**Aviation Rulemaking Advisory  
Committee; Air Carrier Operations  
Subcommittee; Noise Abatement  
Takeoff Profiles Working Group**

**ACTION:** Notice of establishment of  
Noise Abatement Takeoff Profiles  
Working Group.

[Draft Revised July 24, 1991]

**FIG. 1**

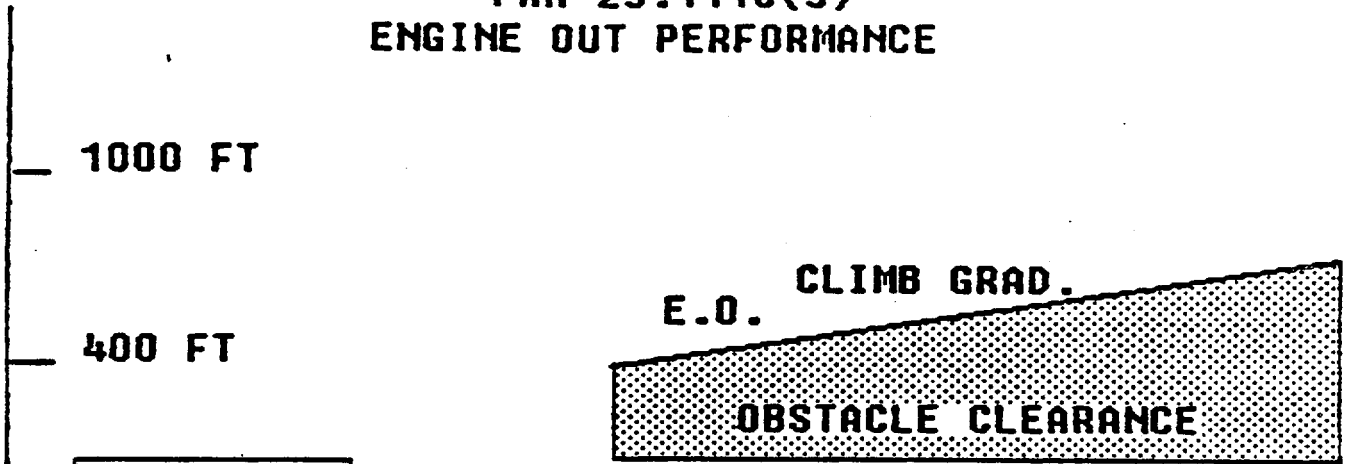
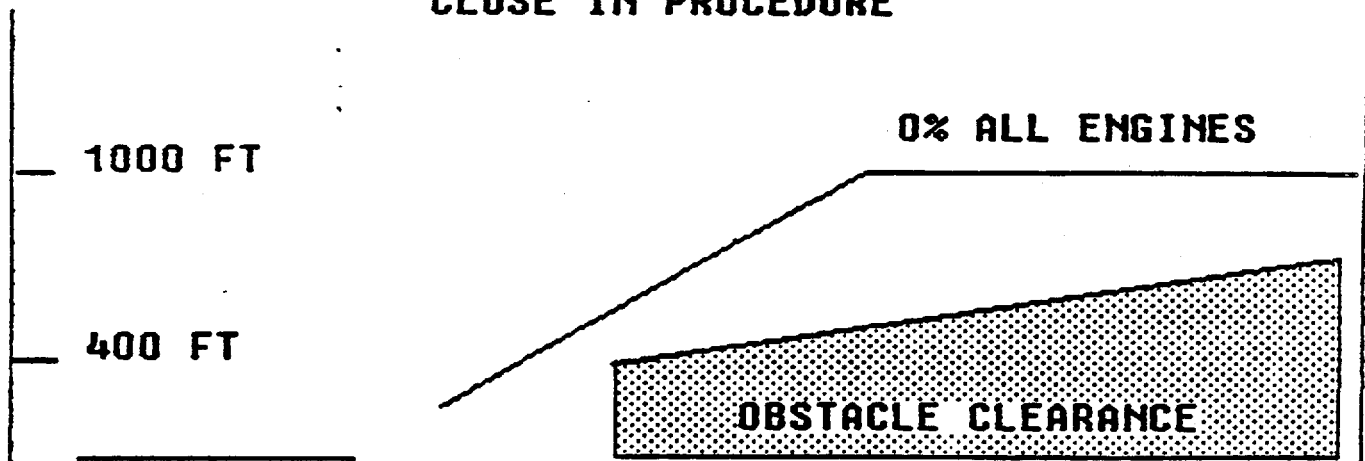
*FAR 25.111(c)(3) specifies an engine out gradient starting at 400 ft. that provides an obstacle clearance path. (See Fig. (1)). Any close-in noise abatement takeoff with a cutback initiated above 400 ft. and the appropriate thrust restoration method can*

*maintain the aircraft at or above the FAR 25.111C(3) obstacle clearance path. (See Fig. (2)).*
